Project:	SE Polk CSD Junior High Lighting Replacement	Project Number:	25-174	Date:	March 20, 2026
----------	--	-----------------	--------	-------	----------------

Note { This addendum has been issued to modify and/or interpret the bidding documents, including the drawings and specifications. Unless otherwise instructed, the information contained on the addendum shall take precedence over anything contrary on the original bidding documents and shall be hereinafter considered as a part of the bidding documents.

Sheet E1.2F – Lighting Plan – Level 2 – Area F

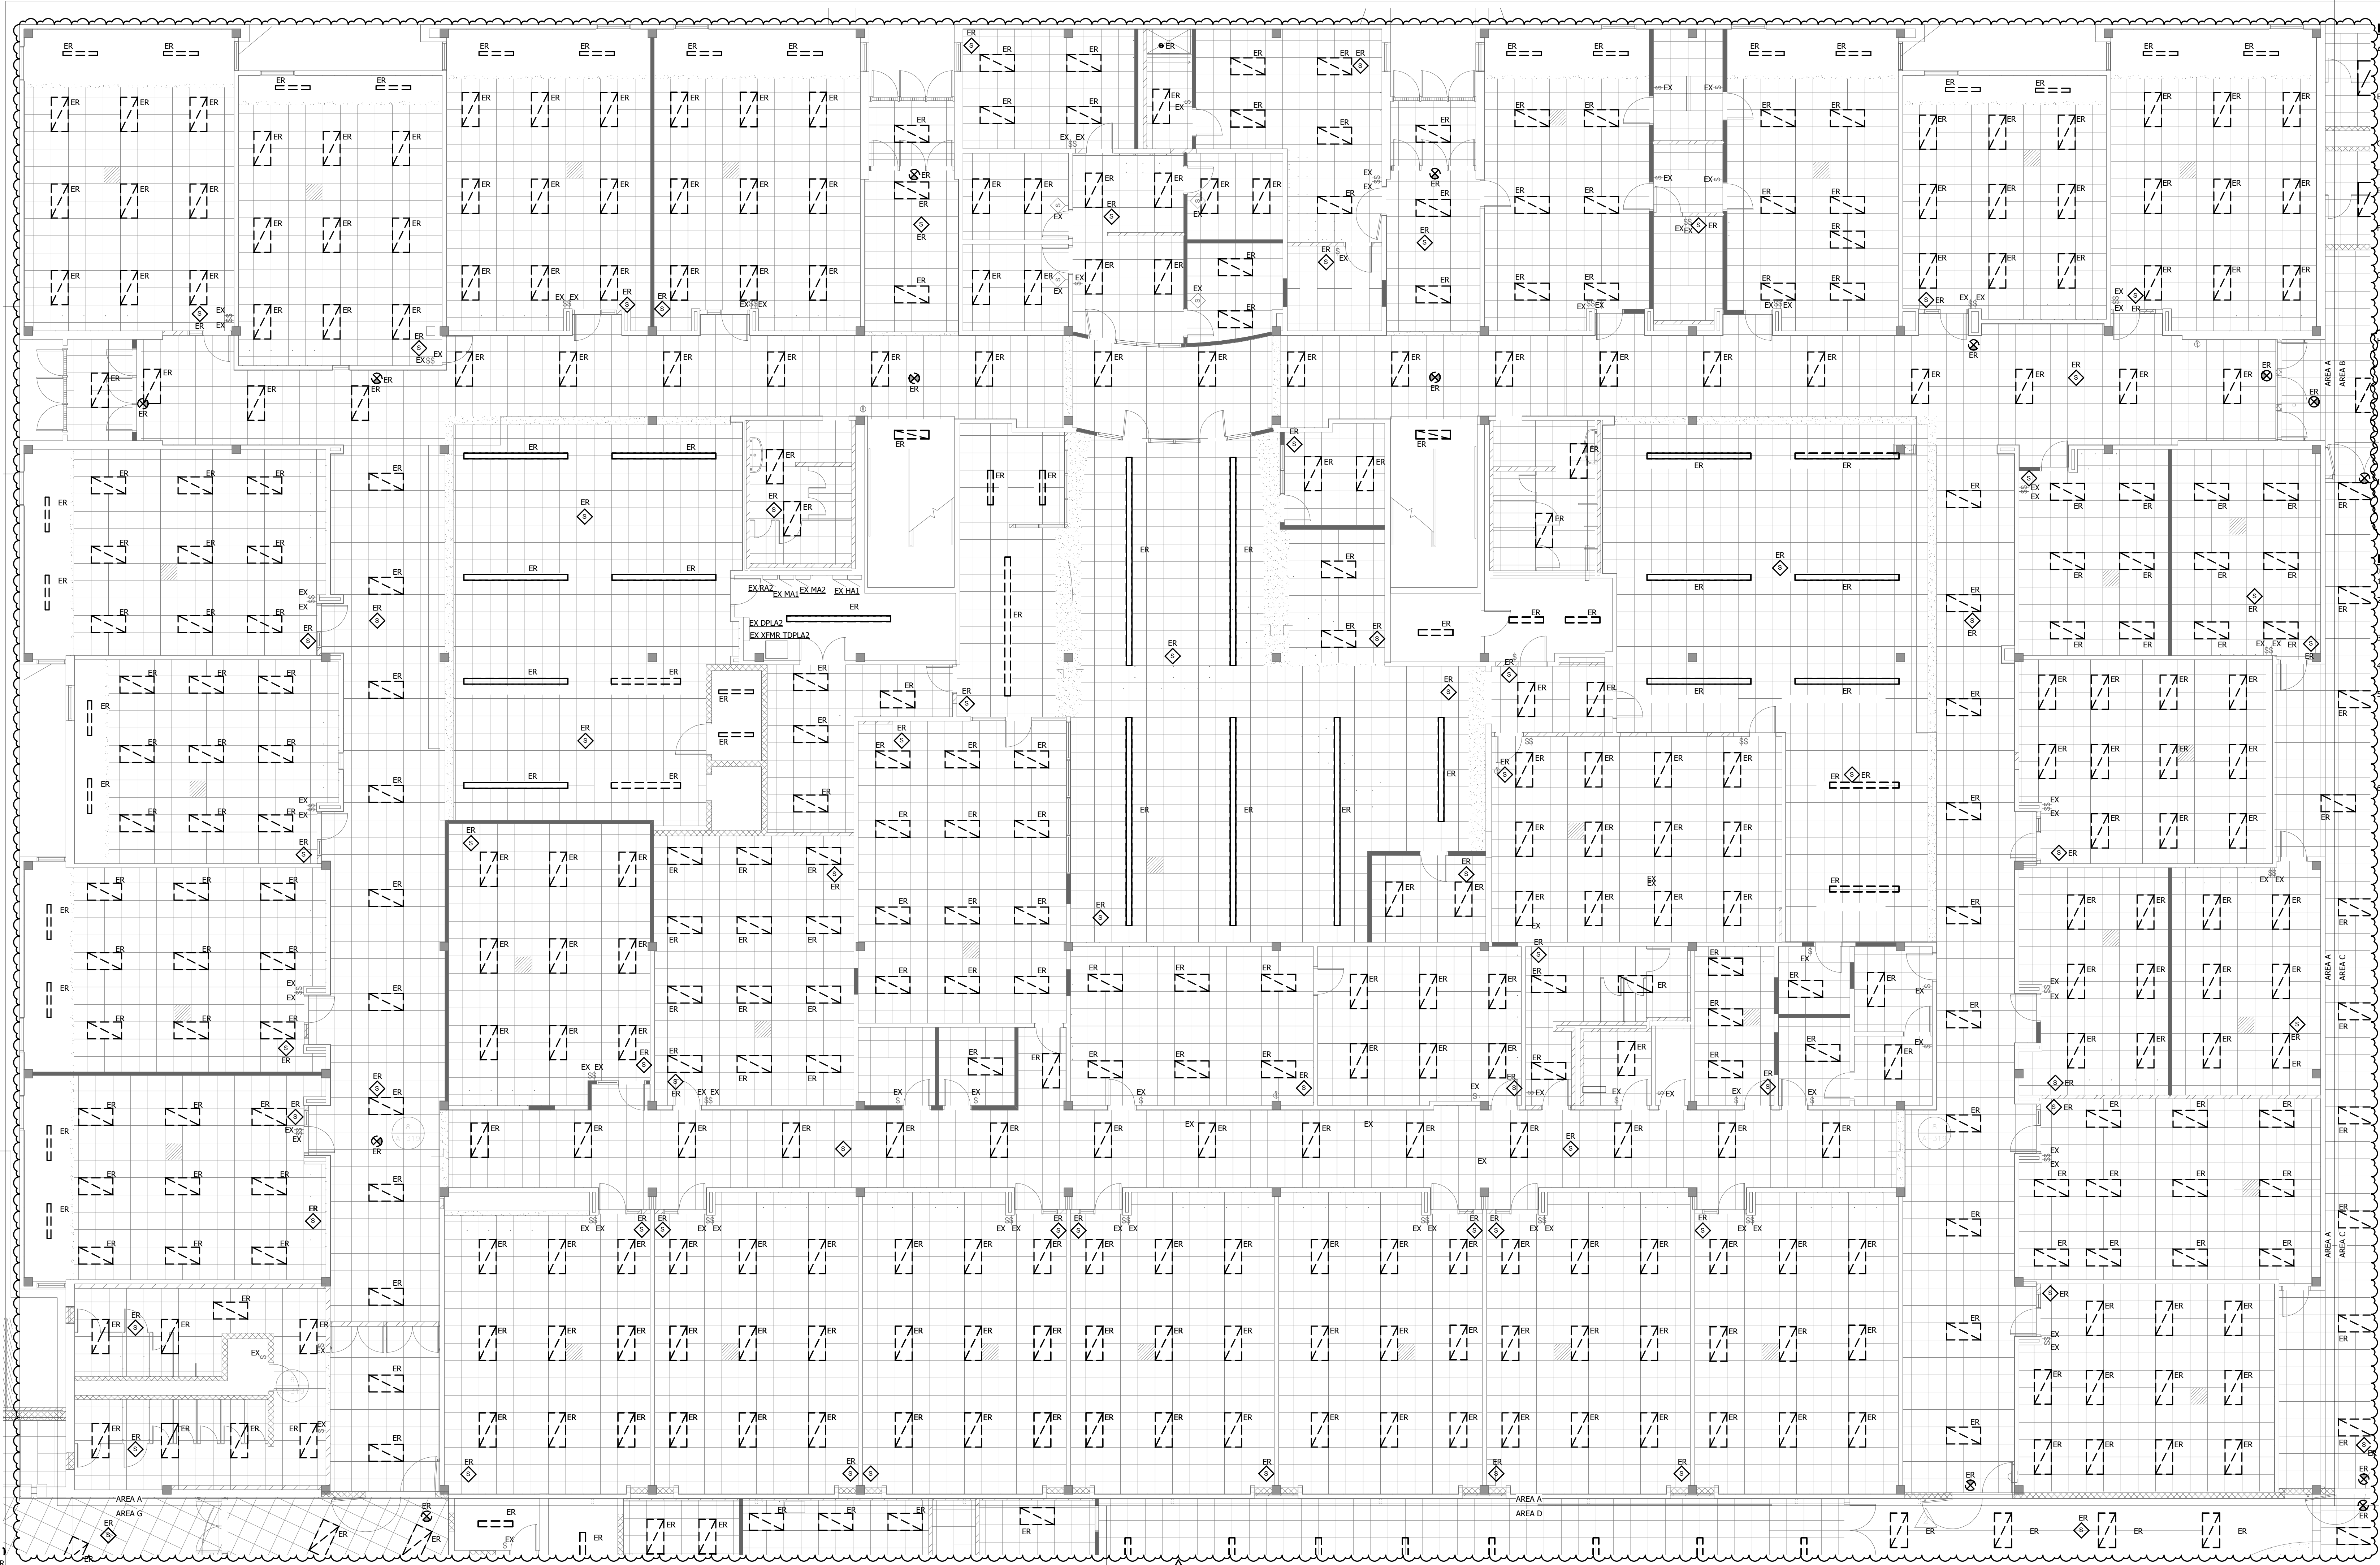
1. **CLARIFY** existing light switches to remain. See drawings for approximate locations.
2. **ADD** new occupancy/vacancy sensors throughout floorplan. See drawings for locations.
3. **ADD** new exit signs throughout the floorplan. See drawings for locations.
4. **ADD** new emergency battery lights throughout the floorplan. See drawings for locations.

5. **REVISE** general note F per attached drawing.
6. **ADD** general note G per attached drawing.
7. **ADD** general note H per attached drawing.
8. **ADD** general note I per attached drawing.
9. **ADD** general note J per attached drawing.

1 LEVEL 1 LIGHTING CEILING DEMOLITION PLAN AREA D
1/8" = 1'-0"

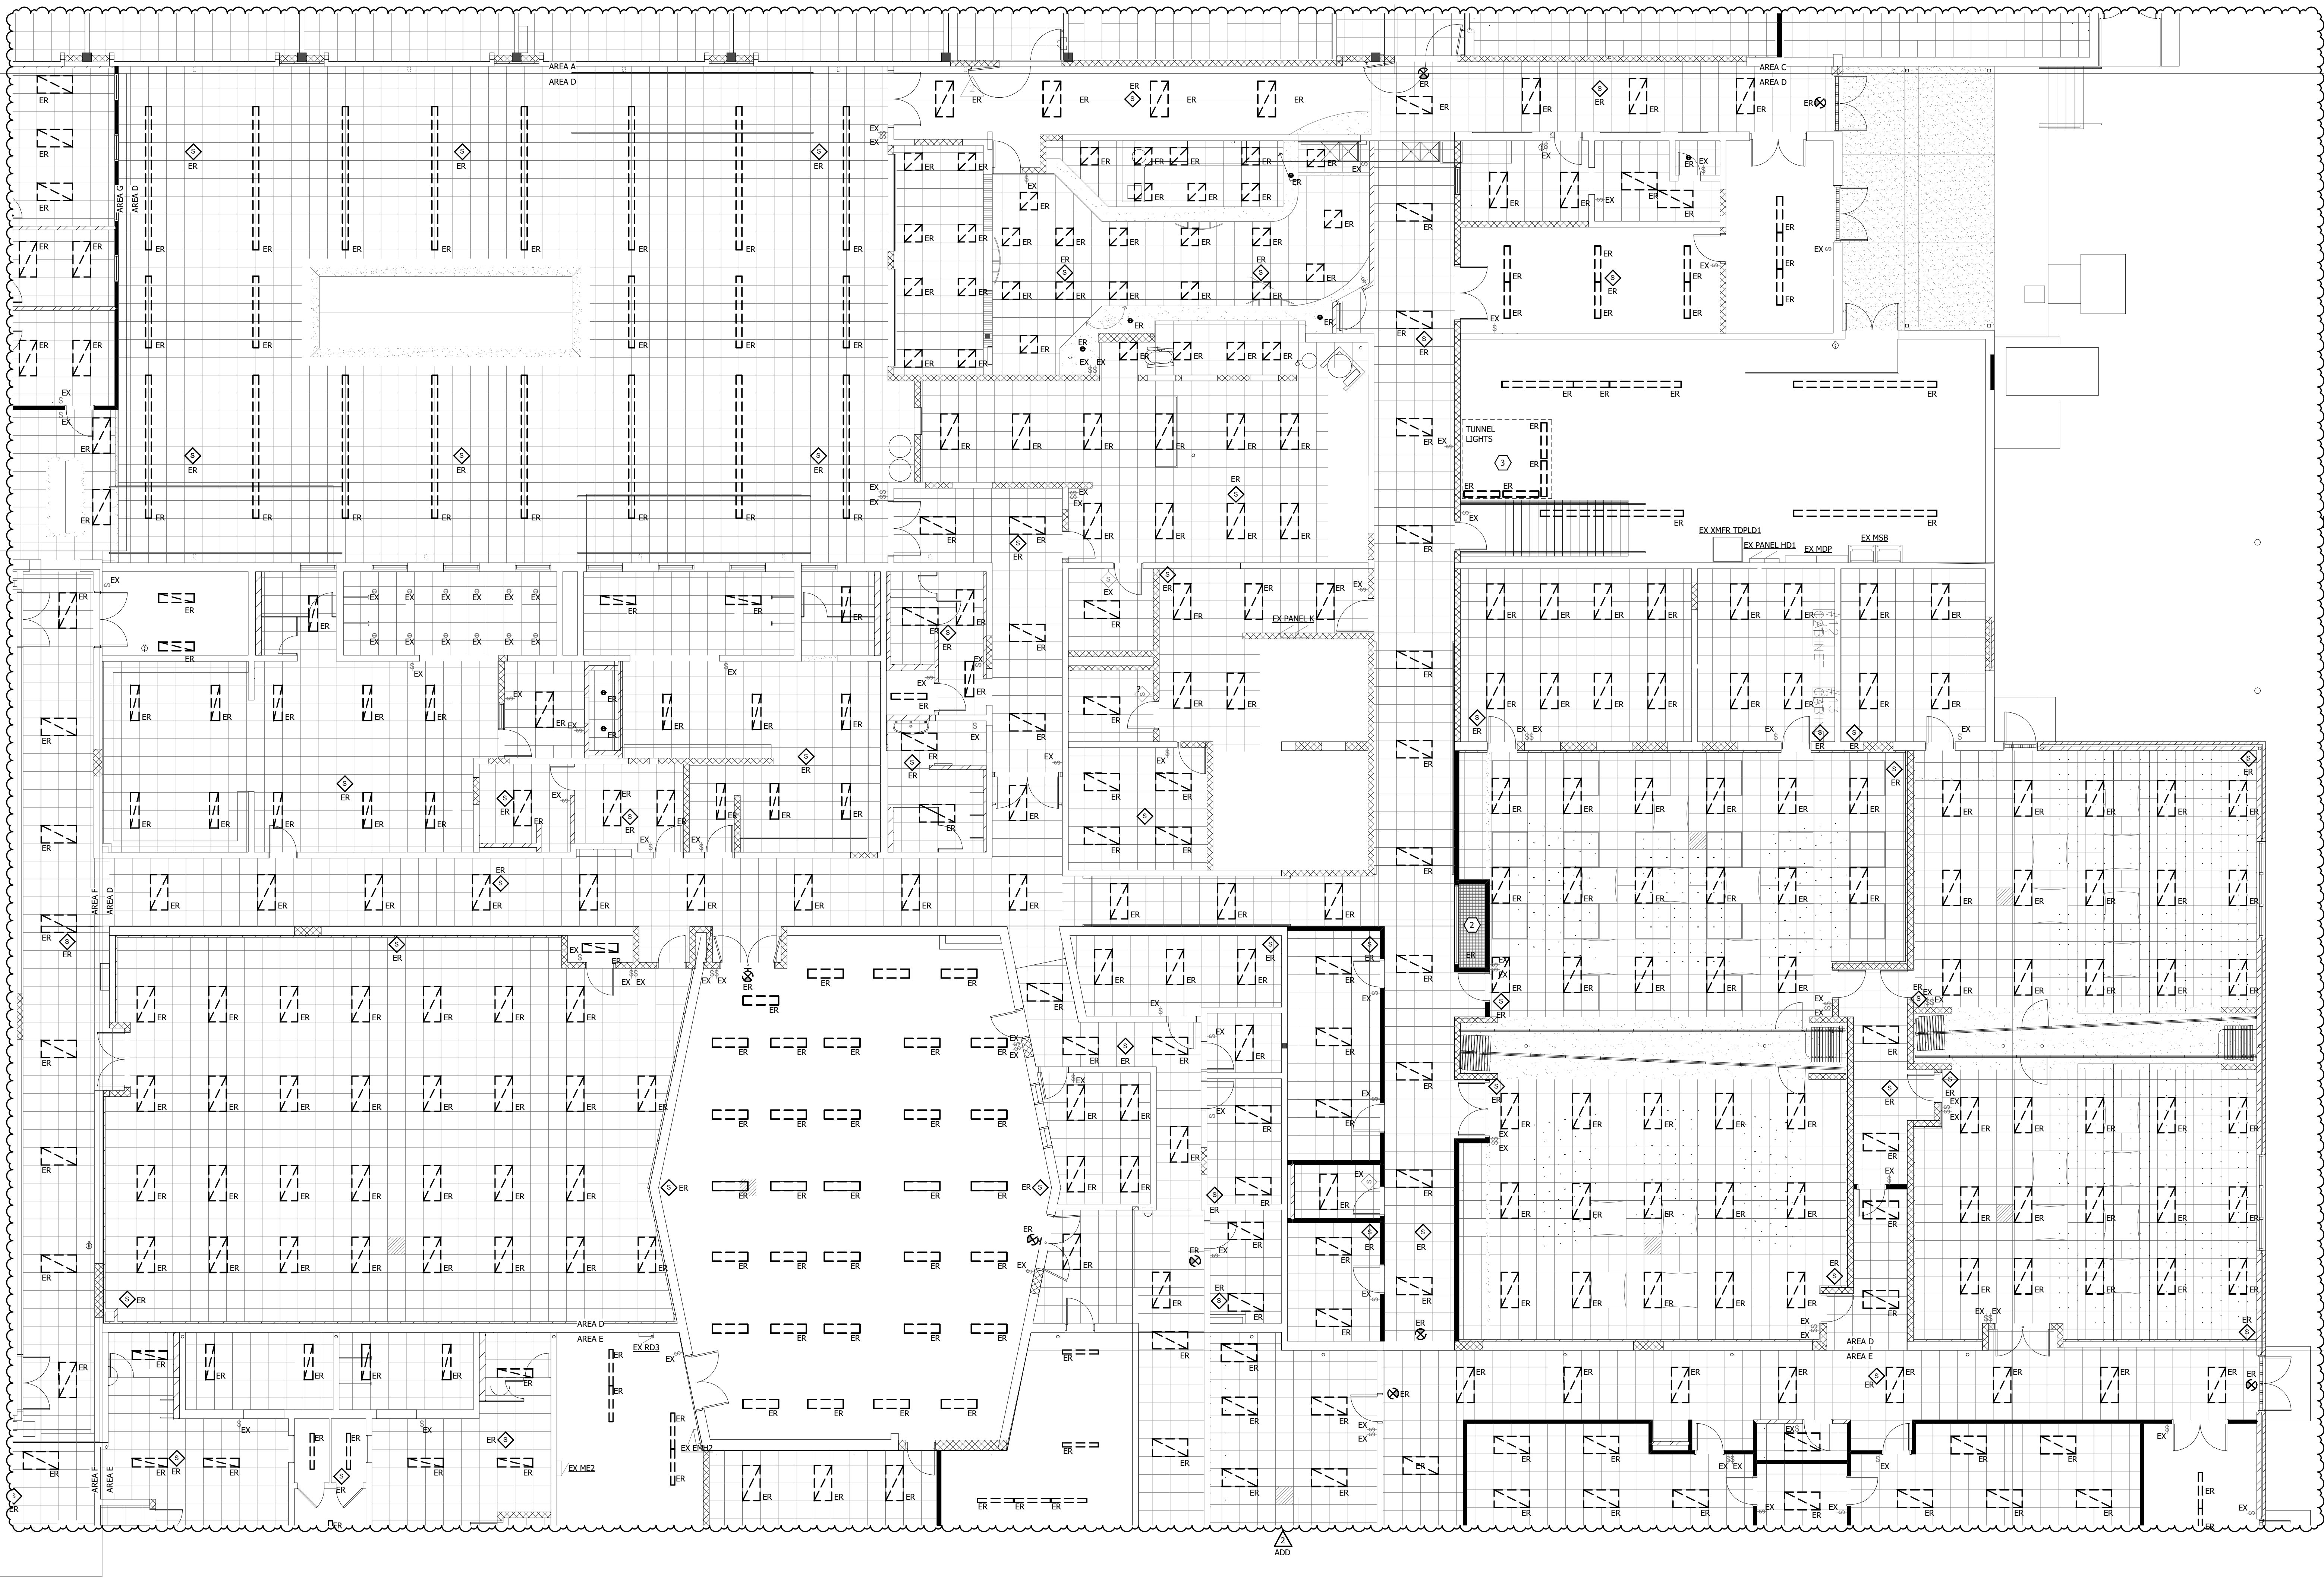
1. **CLARIFY** existing light switches to remain. See drawings for approximate locations.
2. **ADD** existing occupancy/vacancy sensors to be removed and replaced. See drawings for approximate locations.
3. **ADD** existing exit signs to be removed and replaced. See drawings for approximate locations.
4. **REVISE** general note H per attached drawing.
5. **ADD** general note I per attached drawing.
